# City of Richmond

## Report to Development Permit Panel

**File:** DP 18-829236

**Re:** Application by 1132865 BC Ltd. for a Development Permit at 7464, 7480, 7500,  
7520, 7540, 7560/7580 and 7600 No. 1 Road

FLOOR PLAN: CONVERTIBLE UNIT Bc ( BEFORE CONVERSION )

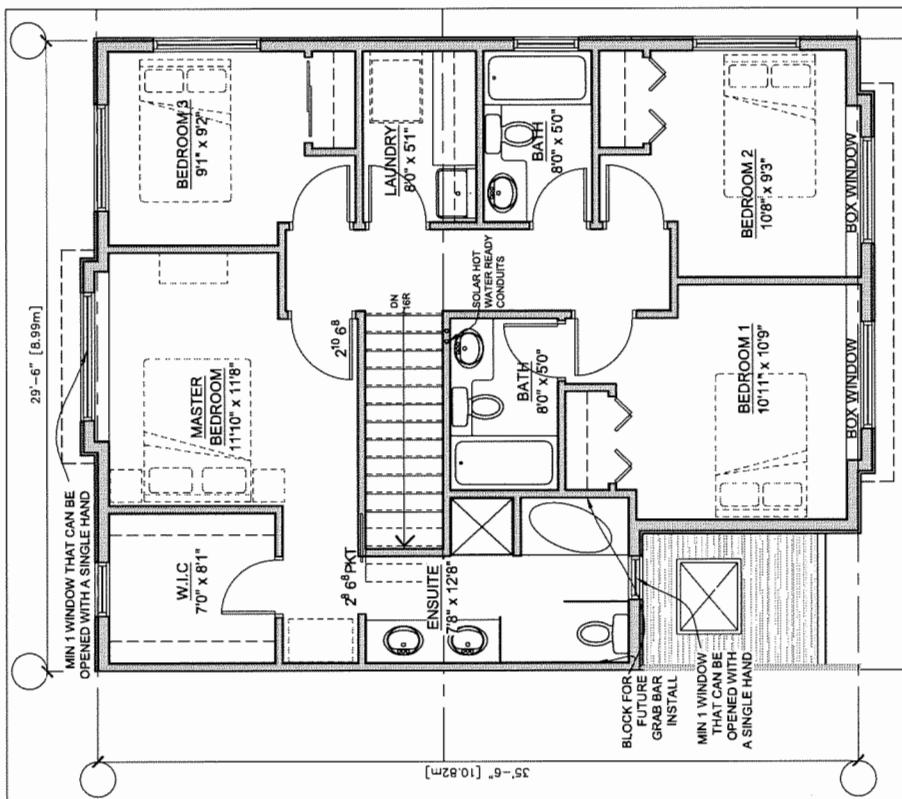
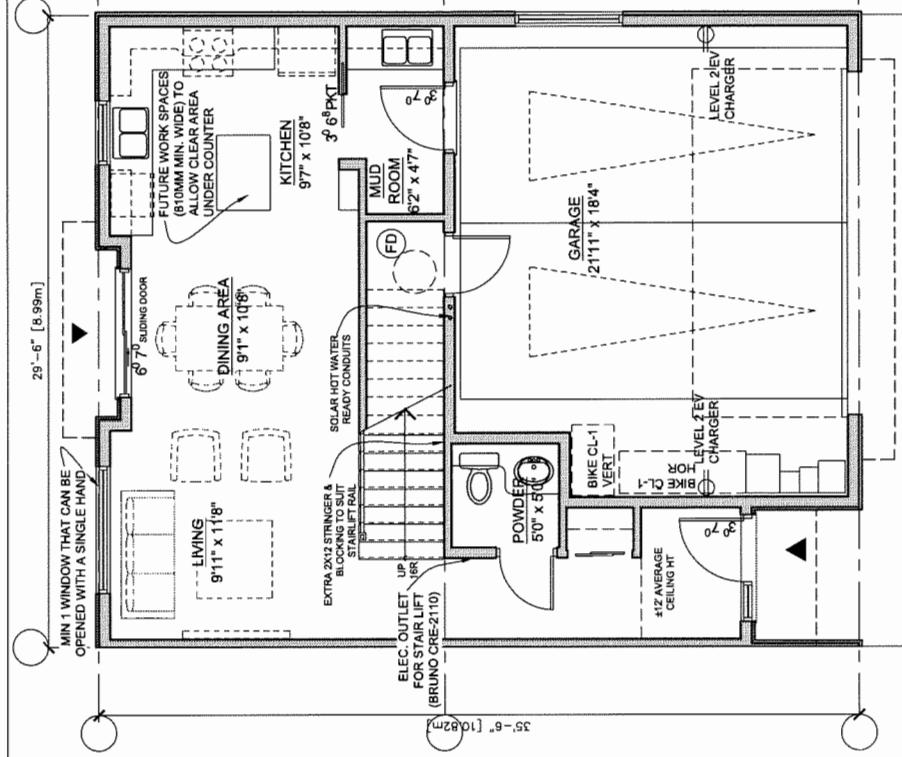
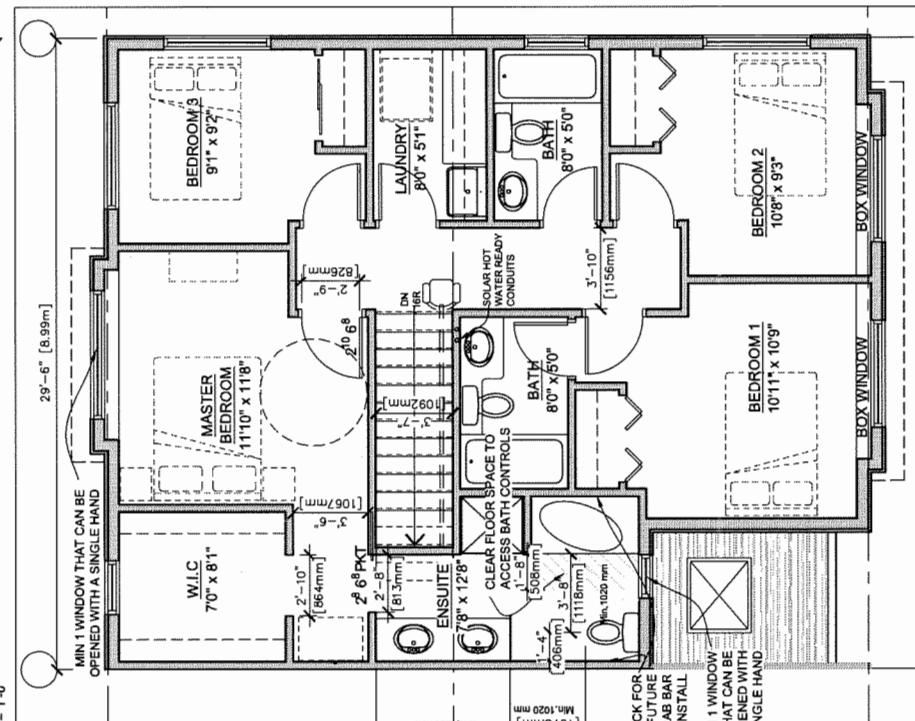
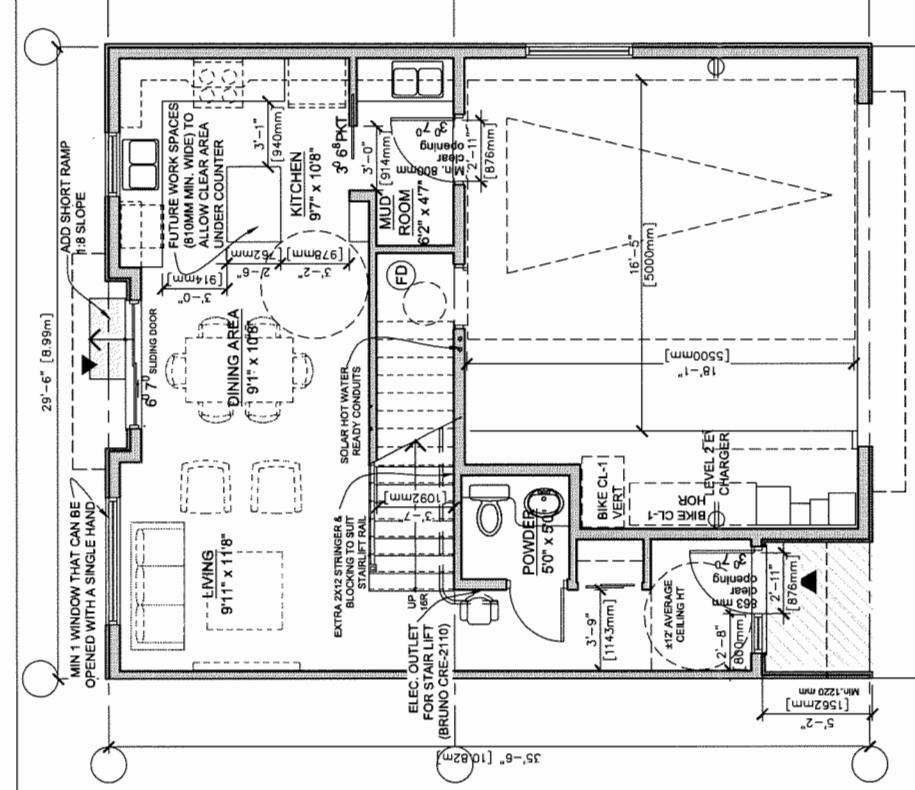
- proposed stairlift for the convertible units is challenging for people with disabilities, e.g. people using walkers and in wheelchairs would require one on each floor; consider accommodating a vertical lift in lieu of a stairlift;  
*Vertical lift considered, but no change. A straight run stairlift is a good solution for convertibility.*
